ADDENDUM ONE

Project: **Sullivan County Immunization**

November 11, 2022

This Addendum is part of the Contract Documents for the above referenced project and modifies the original drawings and/or specifications, dated **10/27/22**, as noted below. The bidder shall acknowledge receipt of this Addendum in the place provided in the Bid Form. The published bid date and time shall remain the same.

DEMOLITION PLAN
1/8" = 1'-0"

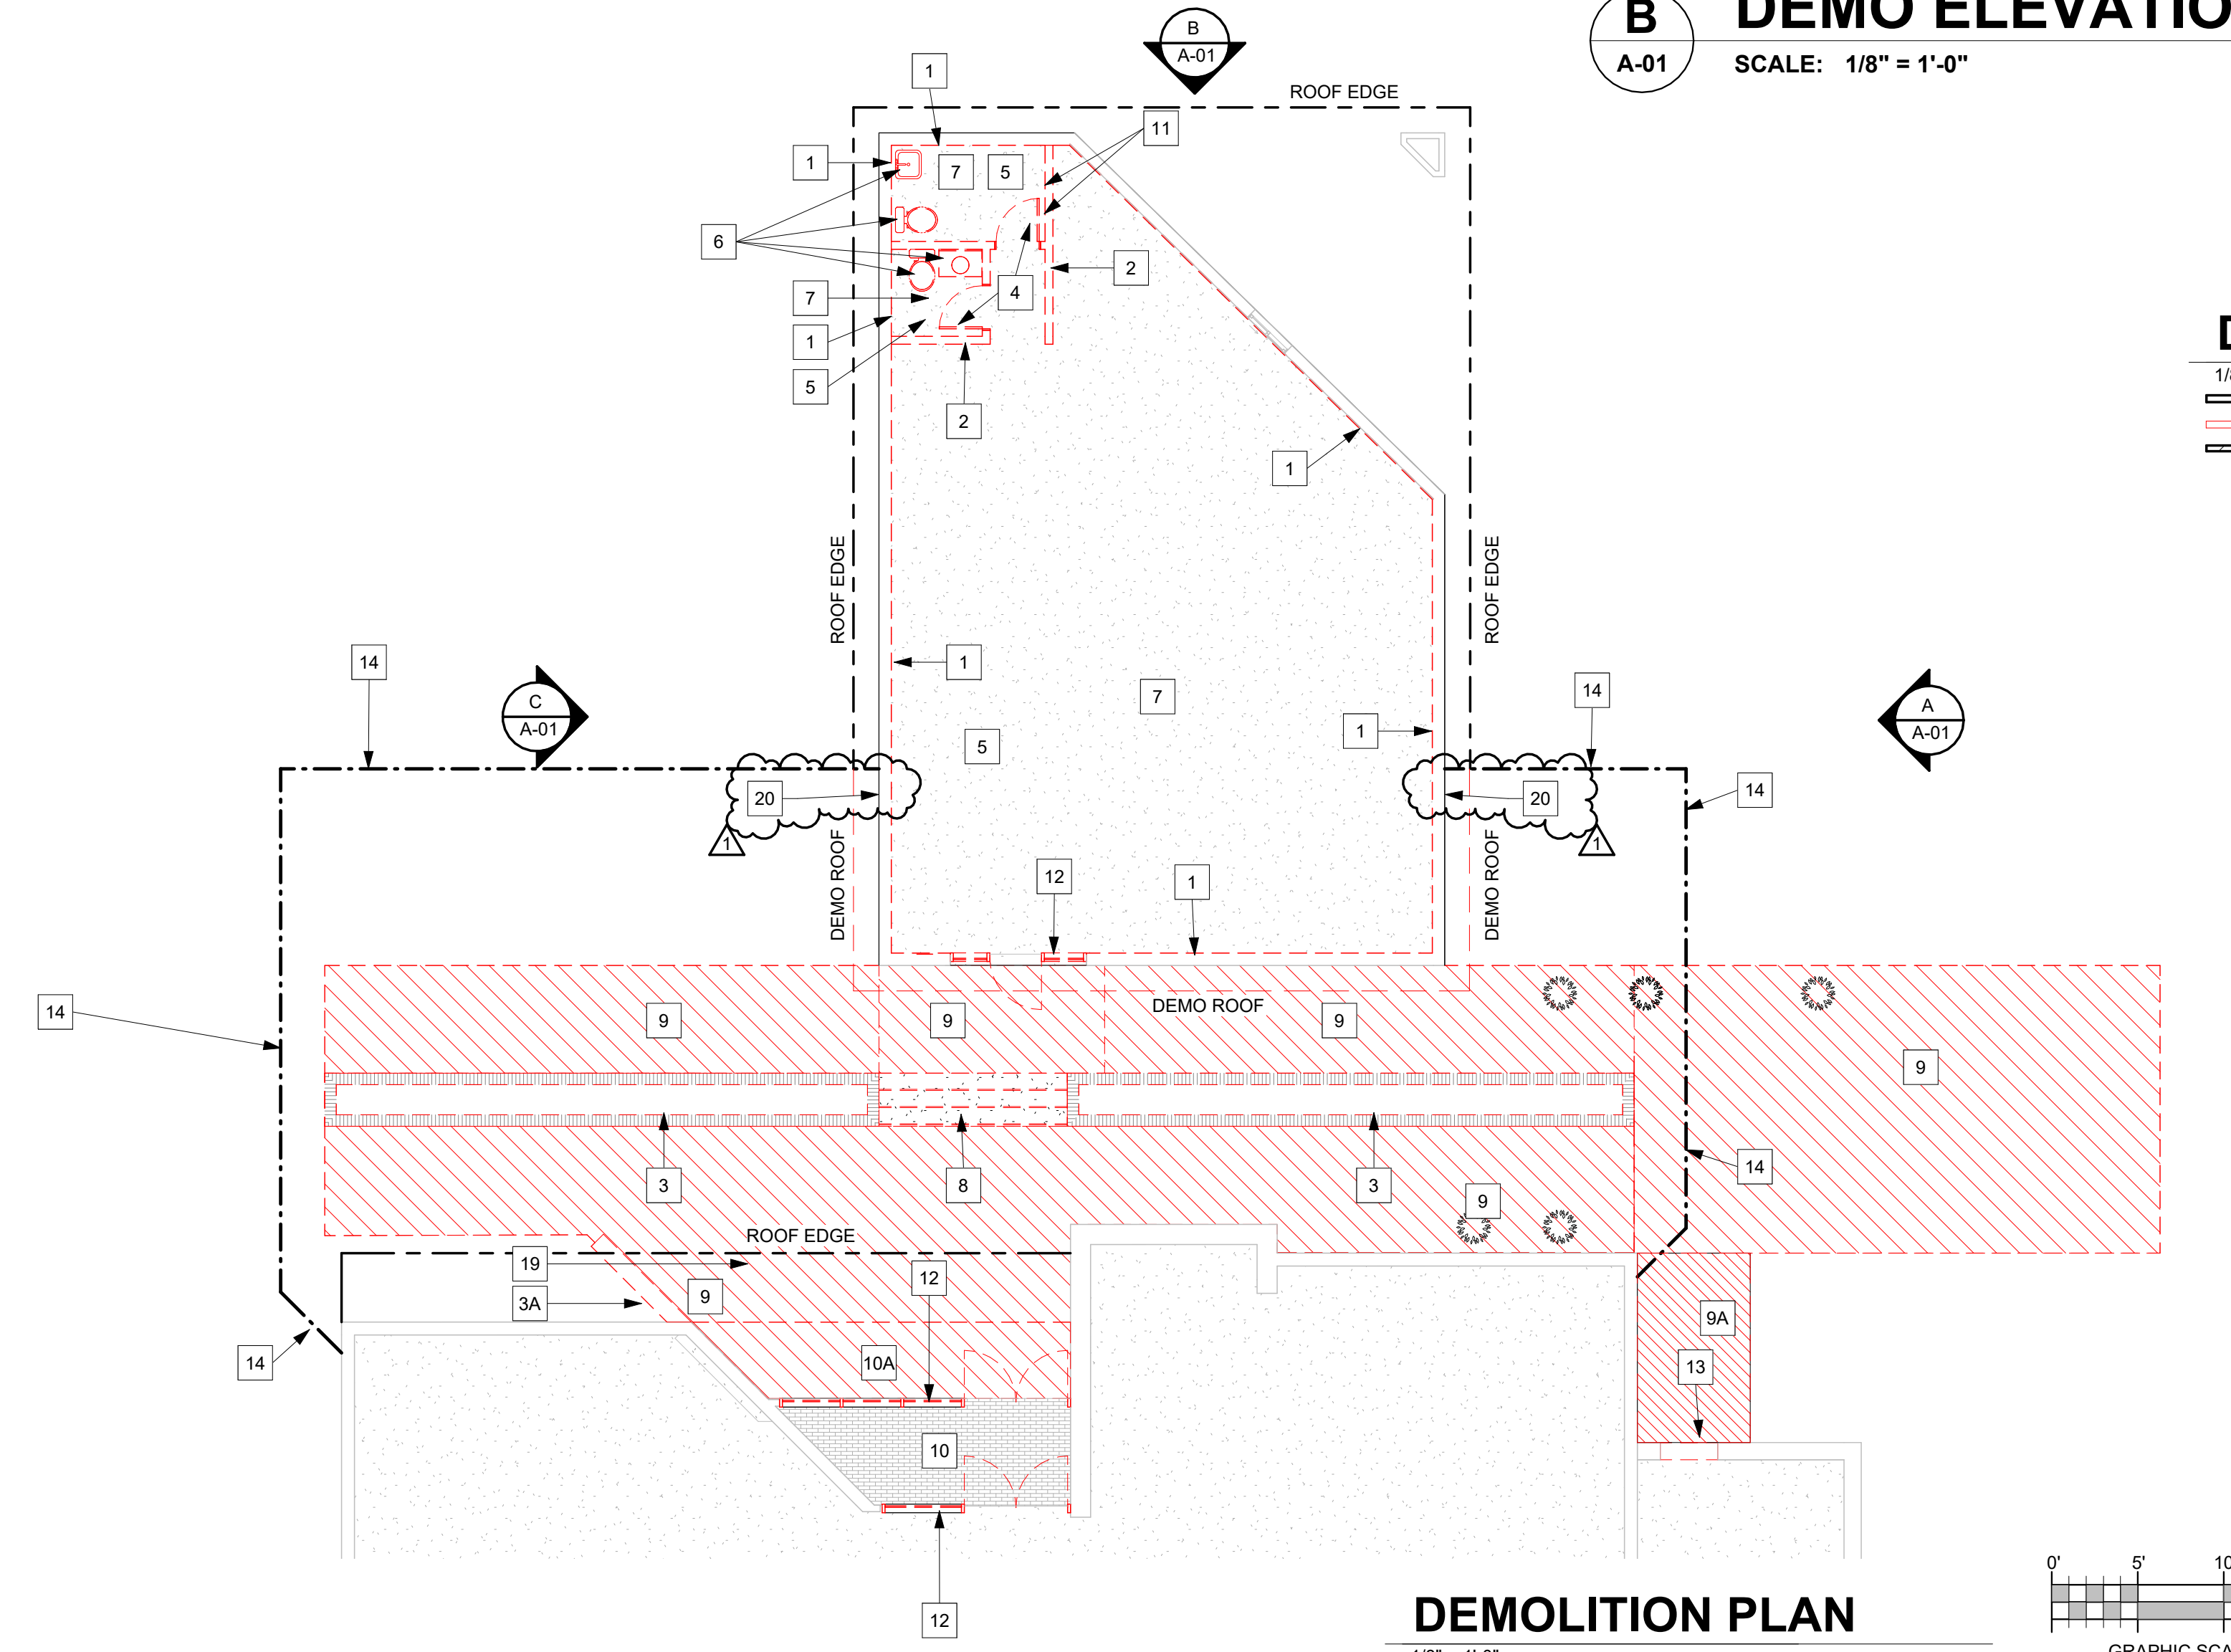
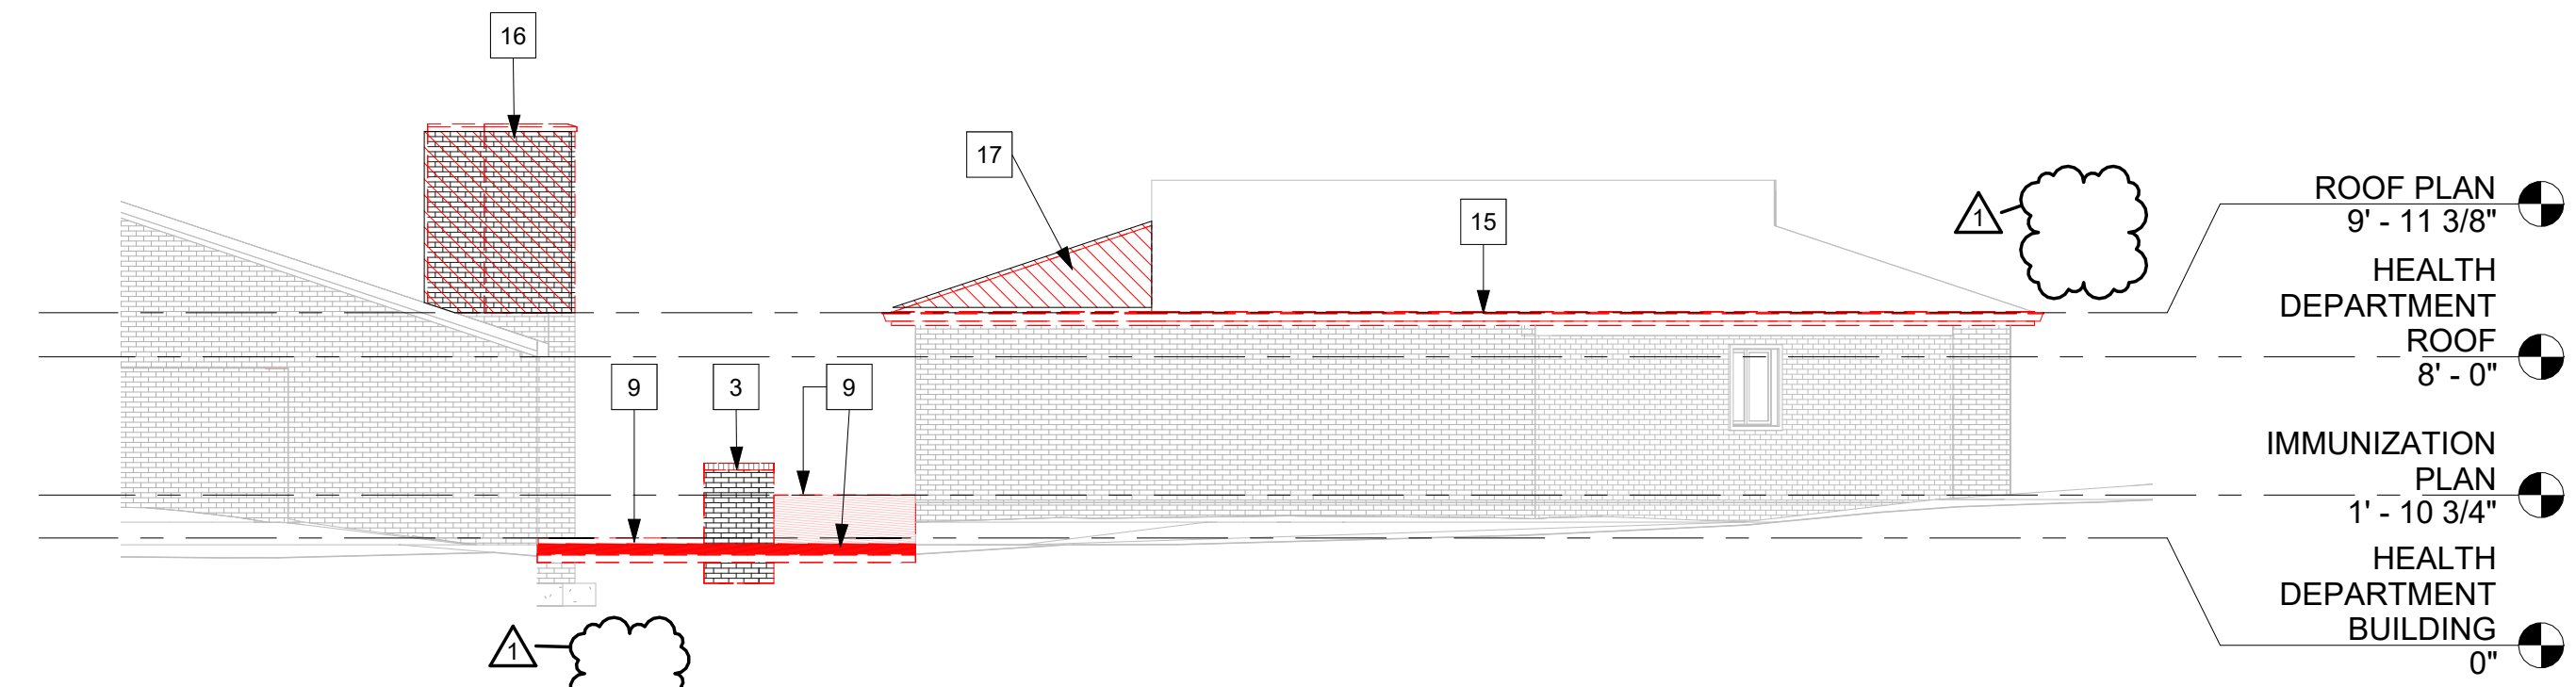
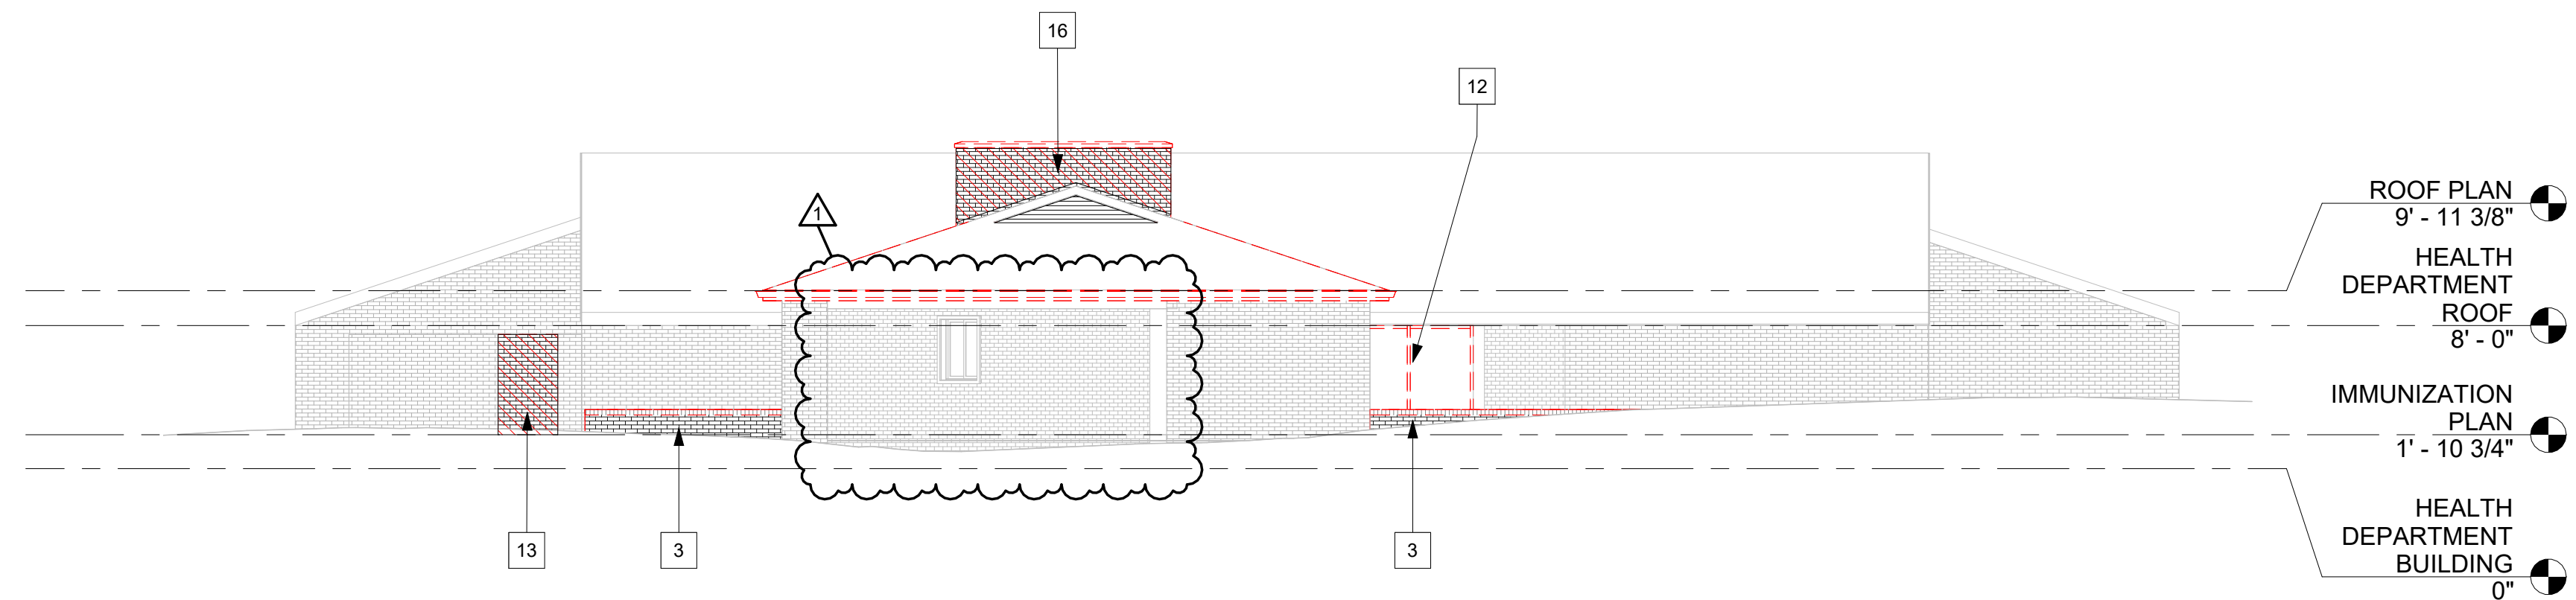
9. **Sheet A-01 Demolition Plan – Base Bid** – remove key note 1, add key note 20.
10. **Sheet A-11 Floor Plan – Base Bid** – change toilet accessories schedule.

- 20 REMOVE EXISTING EXTERIOR WALL SIGNAGE IN ITS ENTIRETY THIS LOCATION. CLEAN BRICK AS NEED TO MATCH ADJACENT BRICK.
